Title: REG1-ControllerESP

Size: A3	Date: 2026-06-26	Rev: V00.32
KiCad E.D.A. 9.0.6		Id: 1/3

Sheet: /
File: REG1-ControllerESP.kicad_sch

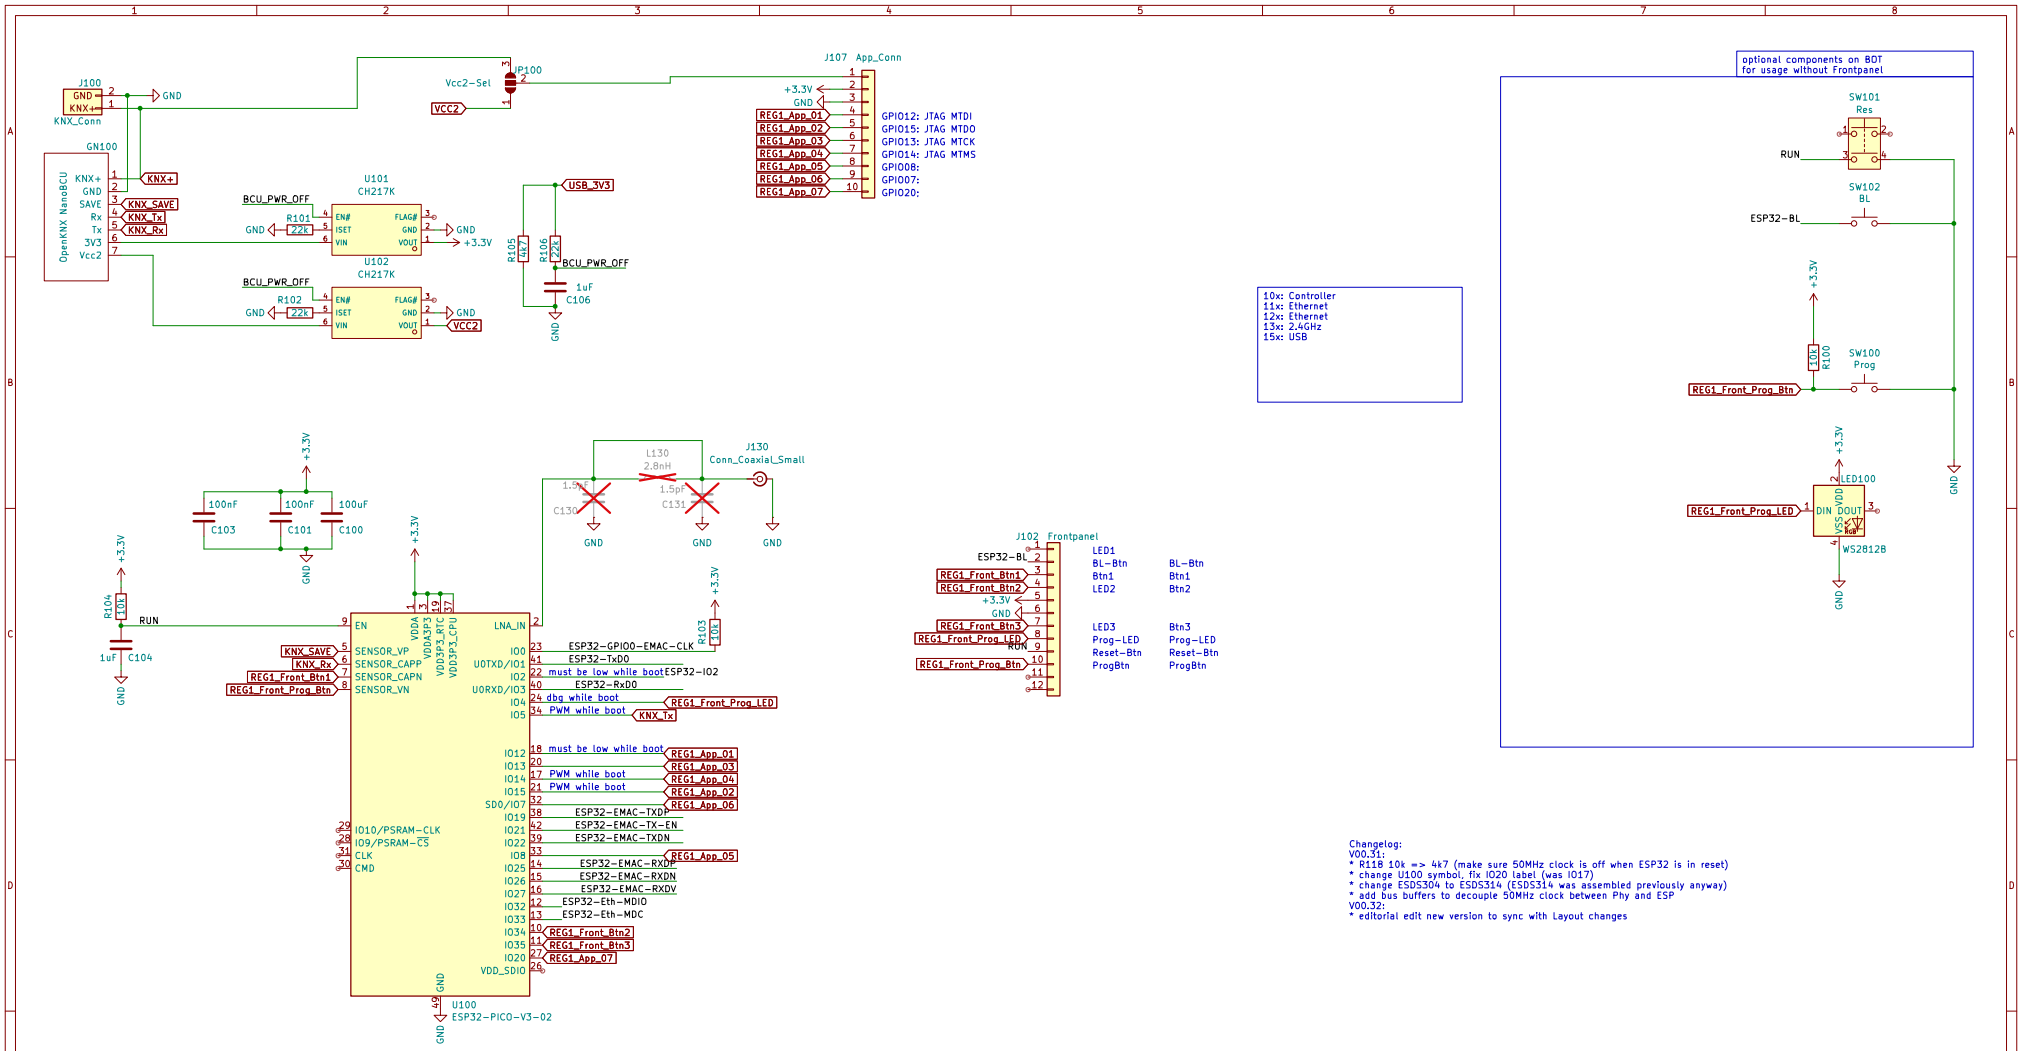
Changelog:
V00.31:
* R118 10k => 4k7 (make sure 50MHz clock is off when ESP32 is in reset)
* change U100 symbol, fix IO20 label (was IO17)
* change ESDS304 to ESDS314 (ESDS314 was assembled previously anyway)
* add bus buffers to decouple 50MHz clock between Phy and ESP
V00.32:
* editorial edit new version to sync with Layout changes
